**Agenda Item:** 8.4  
**Source:** Nokia  
**Title:** **Modification to RNSAP URA/Cell Update Indication procedure**  
**Document for:**

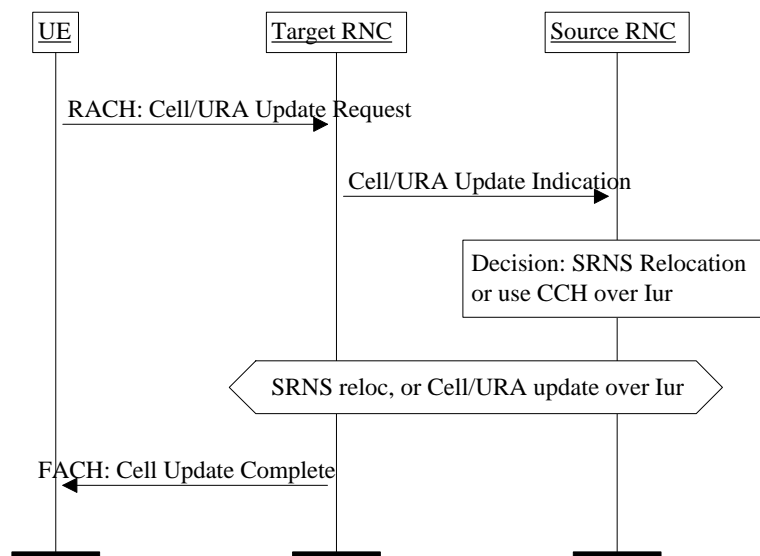
The current Cell/URA Update Indication procedure in Ref. /1/ is used by DRNC to notify the SRNC that the UE has performed an URA or Cell update in the DRNS. Then the SRNC decides whether to initiate a SRNC relocation or to perform the cell update without relocating the SRNC (using Iur control plane and user plane protocols). The situation is shown in the Figure below.

The Cell/URA Update Indication message has to be used by the DRNC to indicate immediately if it cannot accept a cell update without SRNC relocation i.e. it cannot accept CCH traffic over the Iur interface for this specific UE. This is more efficient and faster than a 'failure' message during the CCH initialisation procedure (the procedure is still FFS).

The proposal is to include the following text at the end of the third paragraph in section 9.2.2.1 (Cell/URA Update Indication procedure), Ref. /1/:

*DRNC indicates in the Cell/URA Update Indication message if the SRNC is not allowed to perform the cell update without the SRNC relocation.*
